Product Transition Notice		Date 1 Oct 2014
Product	Digi TransPort®, ConnectWAN® and ConnectPort® – Gobi 3000 Module Migration Notice	
Notice Number	141001-0833

Product Notice	<p>Huawei has discontinued module support for their Gobi 3000 embedded WWAN module. As a result, Digi is replacing the Gobi 3000-based module (-U8 part numbers, supporting EVDO and HSPA) with new 3G and 4G LTE options. Timing and replacement part numbers are defined below.</p> <p>Last Time Buy: November 28, 2014 (pending availability of modules) Last Time Ship: December 31, 2014</p> <p>The supply of Gobi 3000 modules is limited. Customers are encouraged to identify their replacement part number and begin migration as soon as possible.</p> <p>Use the table below and consult with your Digi or Digi partner sales representative to identify the appropriate transition module.</p> <p>Replacement products are certified and orderable now.</p> <ul style="list-style-type: none"> - The -U9 variant supports global HSPA+ networks (e.g. AT&T, Vodafone, Rogers, Telus, Orange) - The -L1 variant supports 4G LTE networks outside of North America and global HSPA+ networks - The -L5 variant uses Qualcomm Gobi® 4G LTE technology t

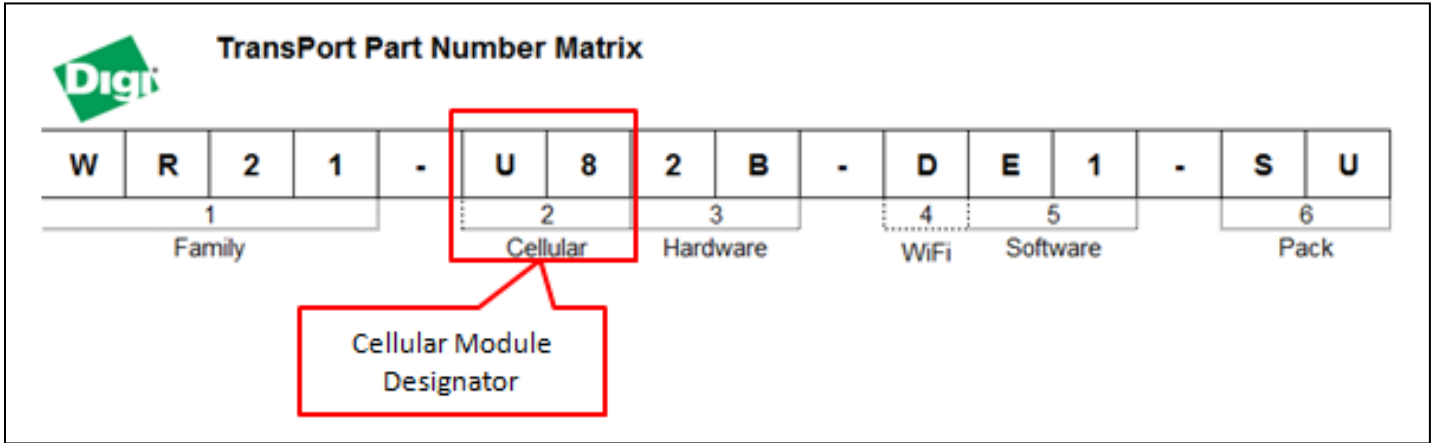
The graphic below illustrates the section of a TransPort model number that identifies the embedded cellular module.

Part numbers with -U8 in Field 2 will migrate to one of the module options described in the chart below.
